CITY OF DALLAS LANDMARK COMMISSION

Tuesday, July 6, 2021

AGENDA

Figure 12 – Proposed Site Plan
CA201-486(LC)

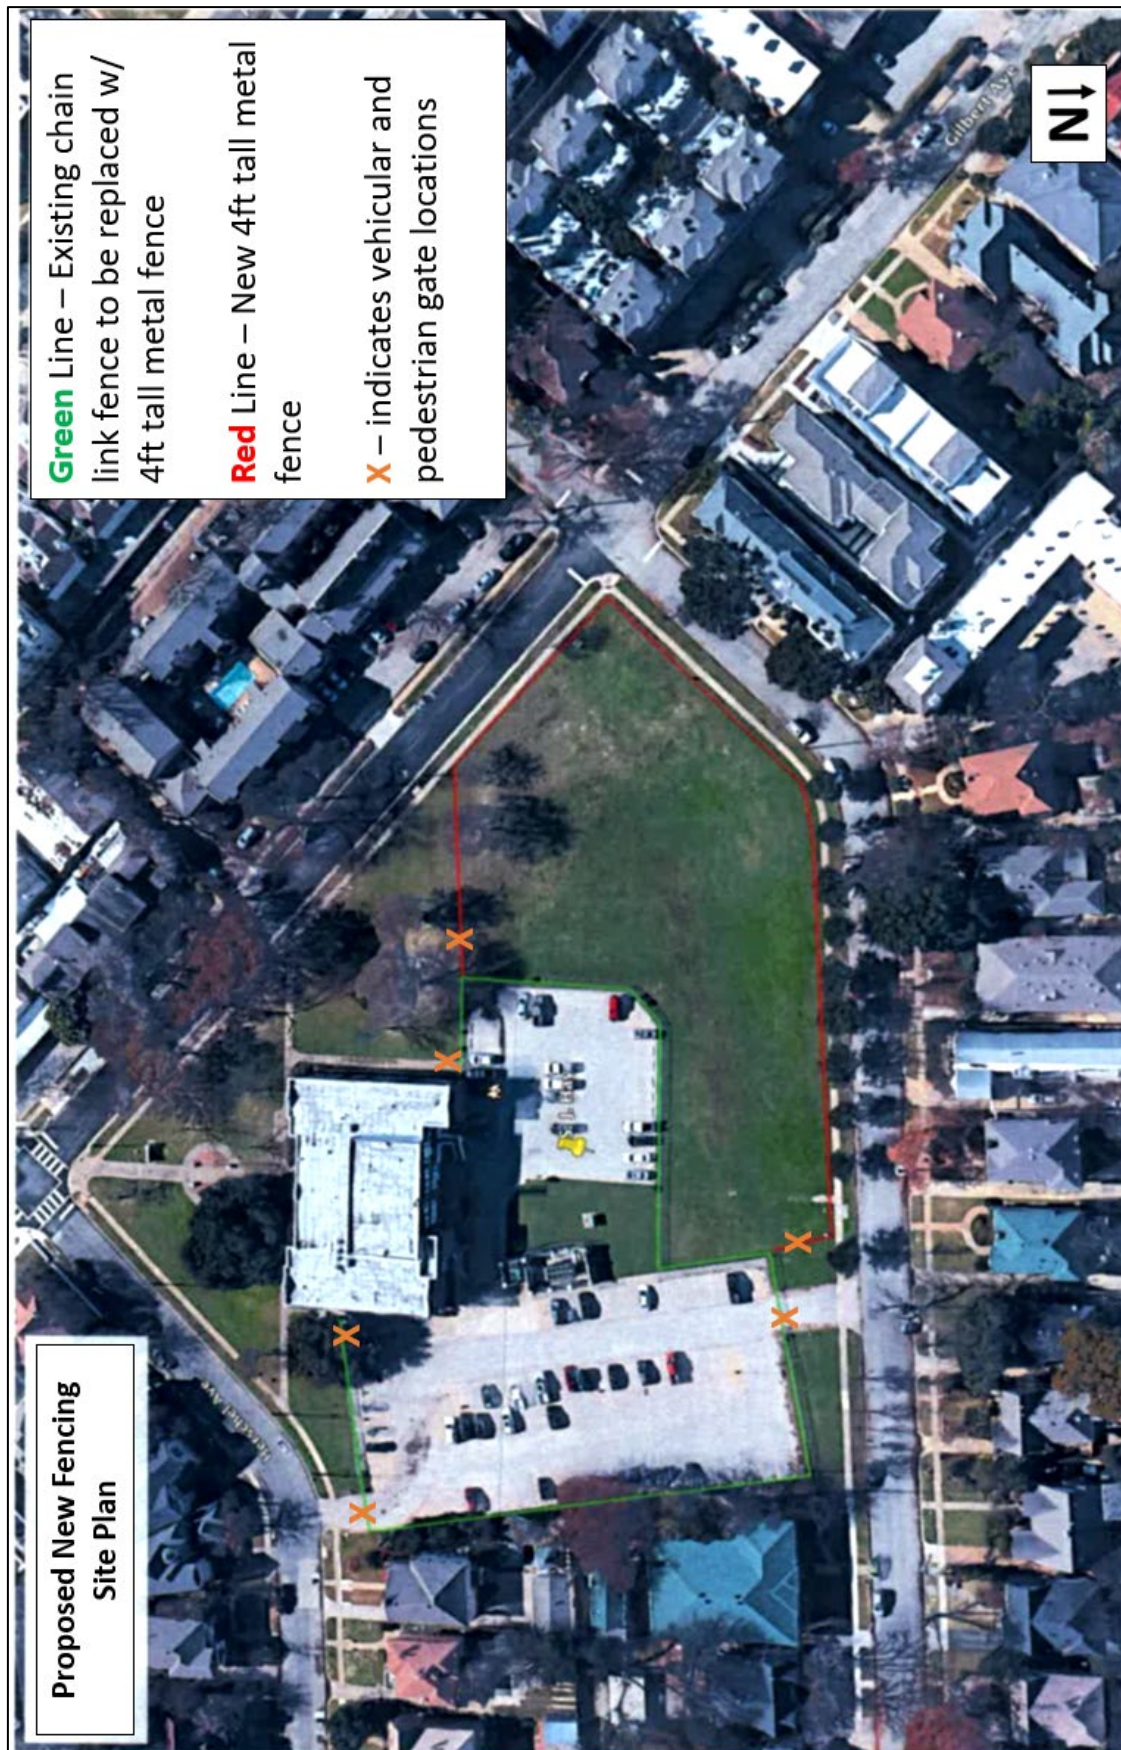
In addition, the applicant is requesting to enclose the northwest section of the property at the rear of the site with the same 4-ft tall aluminum fence. It will include two pedestrian gates (see figure 12 for proposed site plan).

Figure 13 – Proposed 4-ft Metal Railing Design

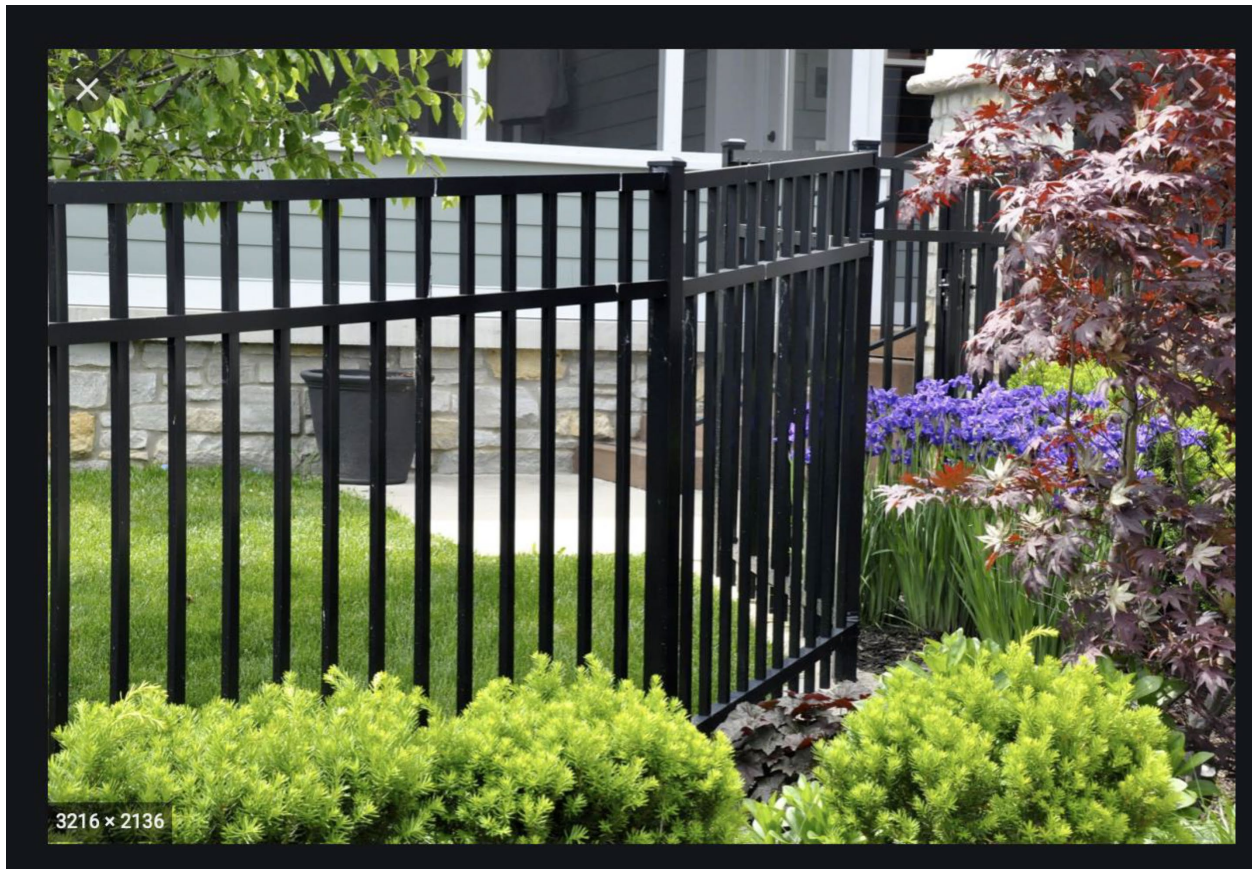
The existing school parking lot is enclosed by a 4-ft tall chain link fence. The proposed work is to replace the chain link fence with a 4-ft tall aluminum picket fence that mimics the look of wrought iron (see figure13 for fence design). It will have a black painted finish. The new fence would be in the same location as existing. Vehicular and pedestrian gates would be in the same locations as existing gates as well.

Figure 9 -- Proposed front and right side elevations.

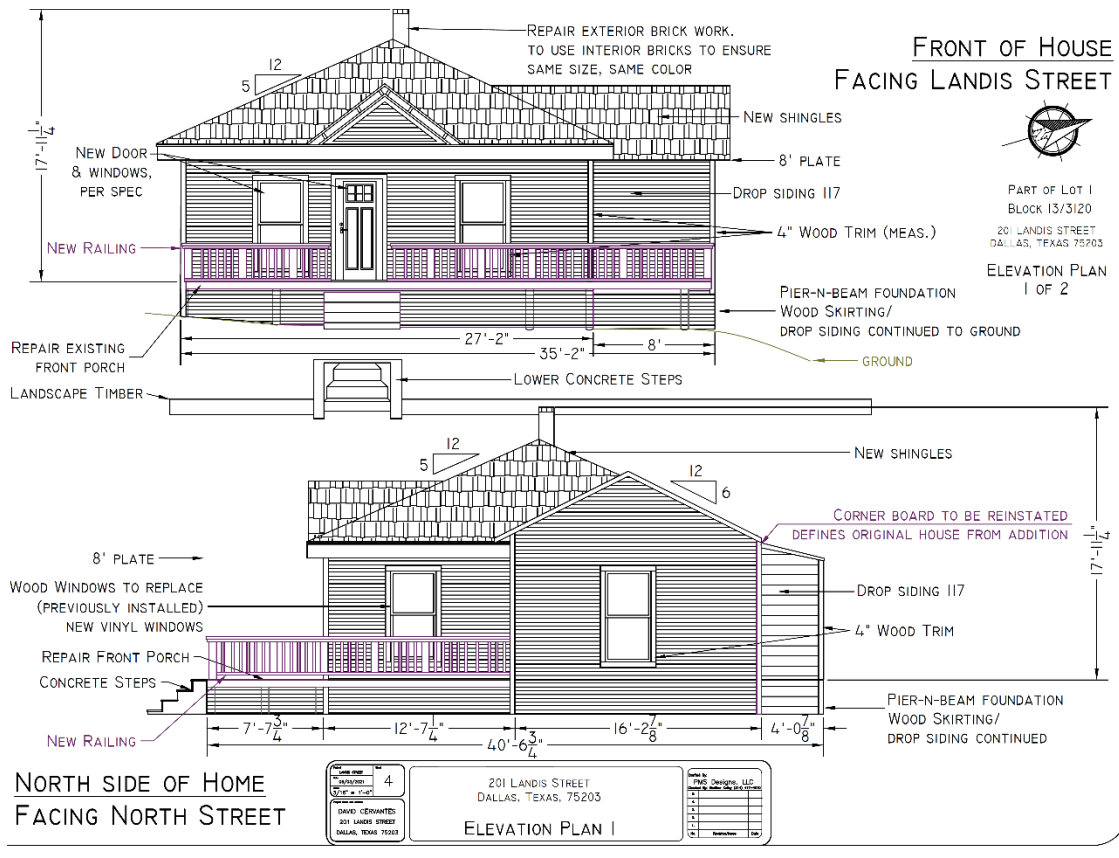
1. Replace 100 percent of non-historic siding with wood #117 siding – Approve drawings dated 7/6/2021 with the condition that all facades be clad in #117 wood siding and that the original frieze board trim be added back into the design with the finding the work is consistent with preservation criteria Sections 2.2 and 2.6 and meets the standards in City Code Section 51A-4.501(g)(6)(C)(i).

1. Replace 100% of non-historic siding with wood #117 siding – We recommend changing the paint color to a lighter color that matches the context of the neighborhood; we recommend changing the siding profile back to the original profile before the illegal renovation.
2. Install wood Craftsman style front door – No recommendation.
3. Replace windows with wood one-over-one windows – We recommend ensuring that an exterior casing frames the window that matches the original.
4. Install one-over-one wood window on rear elevation – No recommendation.
5. Rebuild front porch deck, add railing, and repair concrete steps – No recommendation.
